Economic Commission for Europe
Inland Transport Committee
Global Forum for Road Traffic Safety
Group of Experts on Road Signs and Signals
Twelfth session

**Report of the Group of Experts on Road Signs and Signals on
its twelfth session**
Contents

A sign-by-sign assessment by the Group of Experts

A, 28 a, A, 28 b, A, 28 c “SIGNS TO BE PLACED IN THE IMMEDIATE VICINITY OF LEVEL-CROSSINGS”

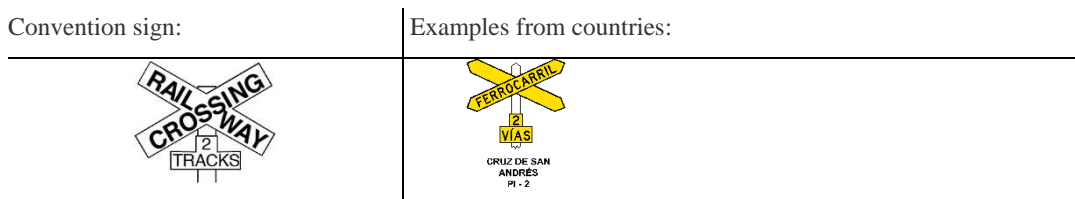
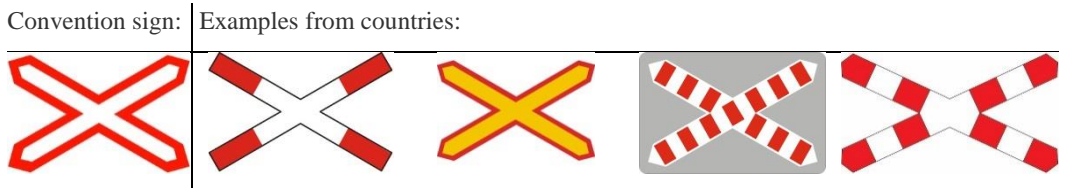
The Group noted that some countries use signs that do not appear to be in conformity with the Convention.

The Group recommended to pair the signs A, 28 a and A, 28 c (with no additional panel) to indicate the immediate vicinity of railway line with one track and to pair the signs A, 28 b and A, 28 c (with additional panel) to indicate the immediate vicinity of railway line with at least two tracks.

(b) Models A, 28 a and A, 28 ~~b~~ **c** shall have a white or yellow ground and a red or black border **or may show red stripes (with or without a red or black border) on condition that neither the general appearance nor the effectiveness of the signs is impaired thereby**; model A, 28 ~~e~~ **b** and **A, 28 d** shall have a white or yellow ground and a black border; the inscription on model A, 28 ~~e~~ **b** and **A, 28 d** shall be in black letters. Models A, 28 ~~e~~ **b** and **A, 28 d** shall be used only if the railway line comprises at least two tracks; with model A, 28 ~~e~~ **d** the additional panel shall be affixed to indicate the number of tracks.

B, 4 “END OF PRIORITY”

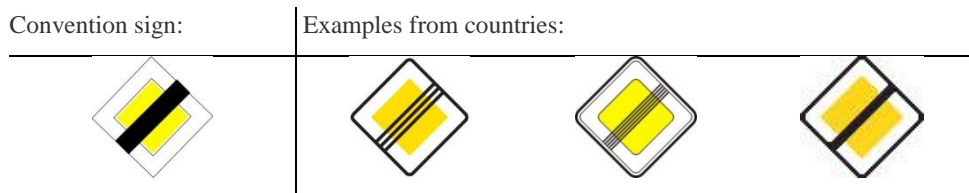
The Group noted that some countries do not use the black rim for the yellow square in the centre, and recommended that they do so.

The "END OF PRIORITY" sign shall be sign B, 4. It shall consist of sign B, 3 ~~above~~ with the addition of a black or grey median band perpendicular to the lower left and upper right sides of the square or, preferably, of grey-black parallel lines forming such a band.

B, 5 “PRIORITY FOR ONCOMING TRAFFIC”

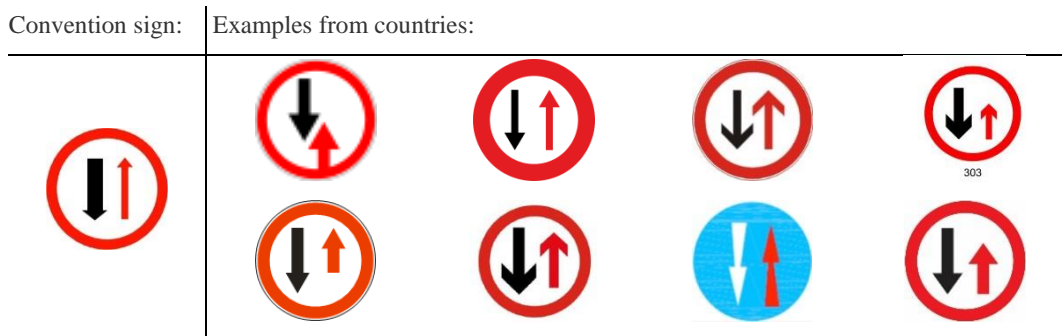
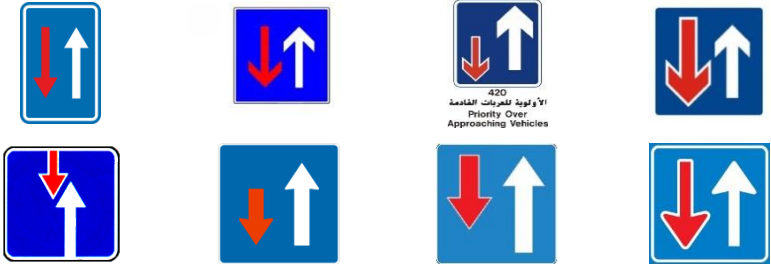
The Group noted that some countries do not use the arrows (i.e. length, width, positioning) as they appear in the Convention. The Group recommended that the arrowheads in the symbol used in Annex 3 of the Convention be enlarged, and that the signs of countries be in line with the revised symbol. The Group also recommended that the following additional words be inserted at the start of the article related to sign B, 5: “The sign indicating priority for oncoming traffic shall be sign B, 5.”

The Group noted that some countries do not use the arrows (i.e. length, width, positioning) as they appear in the Convention. The Group recommended that the arrowheads in the symbol used in Annex 3 of the Convention be enlarged, and that the signs of countries be in line with the revised symbol. The Group also recommended that the following additional words be inserted at the start of the article related to sign B, 6: “The sign indicating priority over oncoming traffic shall be sign B, 6.” To assist colour-blind drivers, the Group recommended that a white rim should be inserted around the red arrow.

D, 8 “END OF COMPULSORY MINIMUM SPEED”

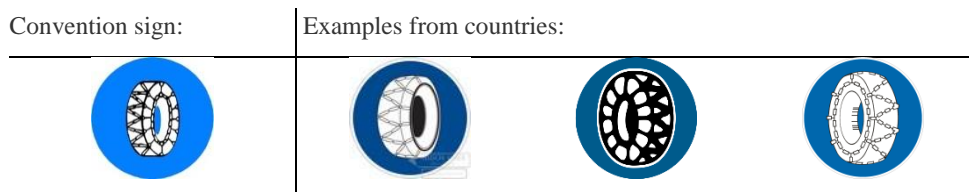
The number should be centred and there should be reasonable amount of distance between the digits (applicable to the Convention’s sign).

The Group decided that too much space between the digits (i.e., Czech Republic) is not in conformity with the Convention. The red oblique bar should be in front of the number and not behind.

The Group recommended to amend the definition for sign D, 8, as follows: Sign D, 8 "END OF COMPULSORY MINIMUM SPEED", shall mean that the compulsory minimum speed imposed by sign D, 7 is no longer in effect. Sign D, 8 shall ~~to be~~ identical to sign D, 7, except that it shall be crossed by ~~an oblique~~ **a diagonal red bar-band or, preferably, of red parallel lines forming such a band** running from the upper right edge to the lower left edge. **The diagonal red band shall have a white rim to separate the red band from the blue ground. The diagonal band can be interrupted when crossing the figure specifying the speed. If not interrupted, the diagonal red band shall be placed over the figure.**

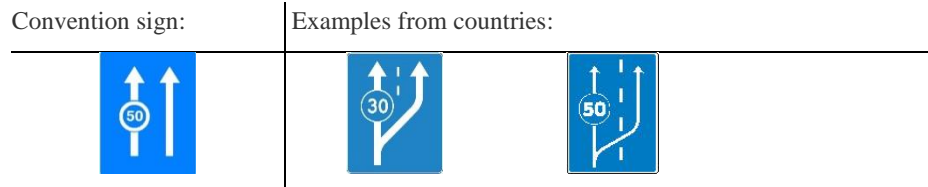
Many countries use road markings (broken line) on this sign. The Group recommended the symbols on this sign not to include road markings ie., broken lines, as the arrows indicate the “lanes”.

The Group recommended that for the E, 1 a sign the sign D, 7 is used with a white rim.

E, 1 b “COMPULSORY MINIMUM SPEED APPLYING TO ONE LANE”

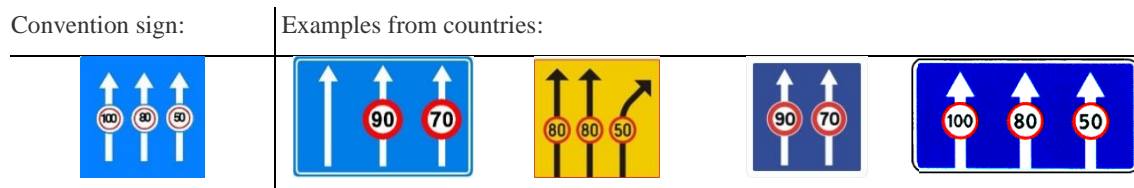
Albania, Croatia and Greece wrongly used examples for E, 1 a instead of E, 1 b.

Many countries use road markings (broken line) on this sign. The Group recommended the symbols on this sign not to include road markings ie., broken lines as the arrows indicate the “lanes”.

The Group recommended that for the E, 1 b sign the sign D, 7 is used with a white rim.

E, 1 c “SPEED LIMITS APPLYING TO DIFFERENT LANES”

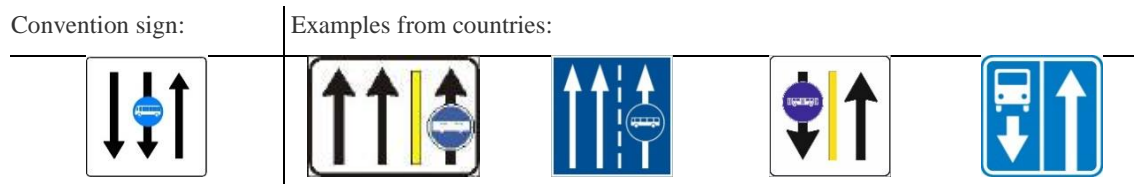
Azerbaijan used a wrong example for E, 1 c sign (truck entry prohibition sign instead of speed limit sign).

The Group recommended that the E, 1 c sign is improved by placing the sign C, 14 on the arrows and adding a white rim.

F, 11 “CARAVAN SITE”

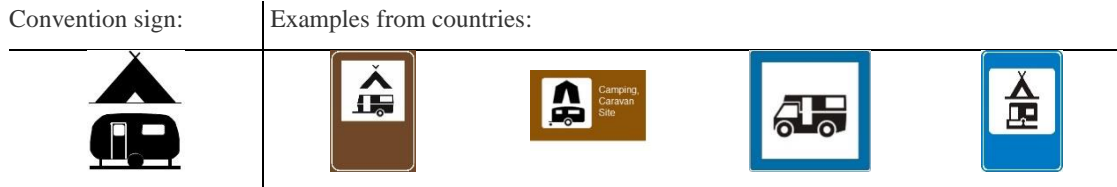
The Group noted that in a number of cases the symbol differs slightly from the one in the Convention but the essential characteristics were retained. The Group also noted that Norway uses the symbol of a motor home (motorised caravan) rather than a caravan, which it considered to be not in conformity with the Convention. The Group believed that the symbol of the caravan used by Ukraine has different characteristics from the symbol in the Convention, and hence is not in conformity. The Group requested that the signs used by Denmark (camping site) be placed under F, 10 only, and the signs used by Nigeria (with the text “motor park”) and Norway be moved to the non-Convention signs.
